Response to Submissions Report

State Significant Development – SSD 9483

Chatswood Public School and Chatswood High School

Prepared for: School Infrastructure NSW
October 2020

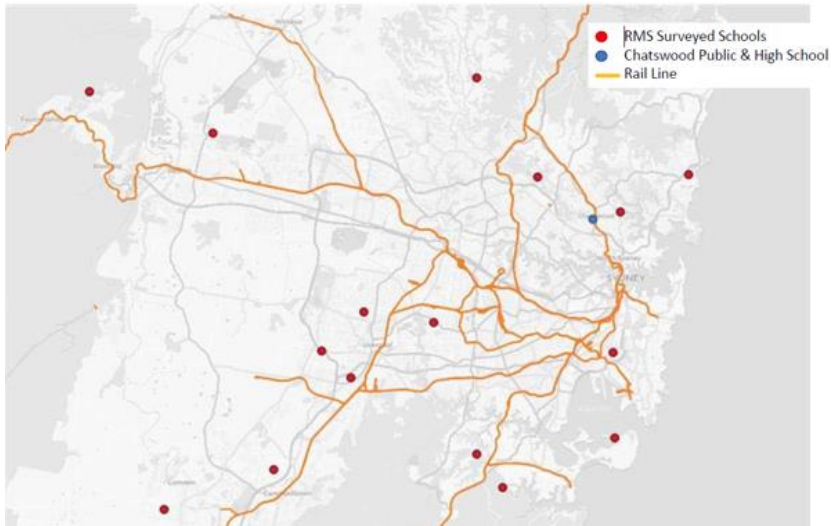
Issue	Response	Reference
	Pacific Highway and that traffic controllers manage vehicle access and pedestrian movement.	
There are existing pedestrian safety concerns at the Victoria Avenue and Pacific Highway intersection with students not using the pedestrian bridge provided in close proximity. The Traffic Impact Assessment refers to a new pedestrian access for the Chatswood Primary School and it is requested that the applicant considers measures to encourage students to use the pedestrian overbridge instead of the signalized intersection crossing.	The pedestrian overpass across Pacific Highway is an attractive option for primary school students when it is operational. However, there are significant maintenance issues that mean the escalators are often not operational. It is our understanding from Willoughby City Council that the pedestrian overpass is privately owned and operated by the land owners of 799 Pacific Highway. Any measures available to the school to encourage students to use the pedestrian bridge in preference to the at grade crossing rely on the operation of the escalators. Notwithstanding, strategies to encourage the use of this overpass will be included in the comprehensive School Travel Plan.	Attachment 3

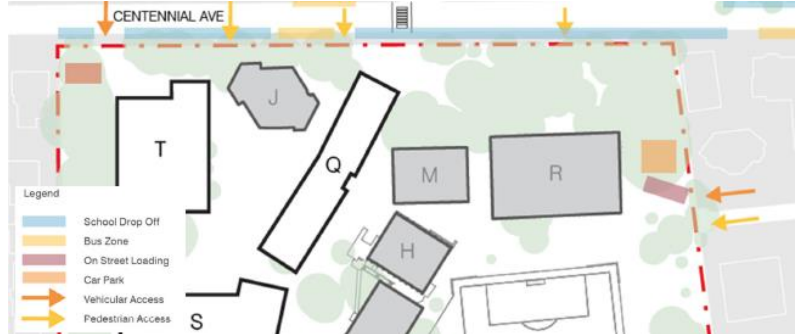
Proposed post construction vehicle and pedestrian accesses at Jenkins Street and Oliver Road should have separate access point/paths for vehicles and pedestrians to avoid pedestrian/ vehicle conflicts.	The proposal includes separate access points for pedestrians and vehicles from Jenkins Street (Figure 4) and from Oliver Road (Figure 5) to avoid conflicts during construction.	N/A

Issue	Response	Reference
	 <p data-bbox="1070 821 1691 853">Figure 4 Proposed access arrangements – Public School site</p>  <p data-bbox="1070 1204 1668 1236">Figure 5 Proposed access arrangements – High School site</p>	
<p data-bbox="273 1268 1046 1316">During construction phase, the 4 available parking spaces should be increased and prioritised for special needs students drop off and pick up</p>	<p data-bbox="1064 1268 1854 1316">These four spaces are reserved for special care pick up and drop off and these are considered sufficient for demand.</p>	<p data-bbox="1937 1268 2078 1292">Attachment 3</p>
<p data-bbox="273 1332 996 1380">It is not clear where school staff parking will be provided during construction phase (which is 36 months). No staff travel plans are provided.</p>	<p data-bbox="1064 1332 1904 1404">Given that both schools will be fully operational during construction, staff car parking during this period is an issue that is being considered as part of the detailed construction methodology. A comprehensive Travel Plan will be developed and implemented for the</p>	<p data-bbox="1937 1332 2078 1356">Attachment 3</p>
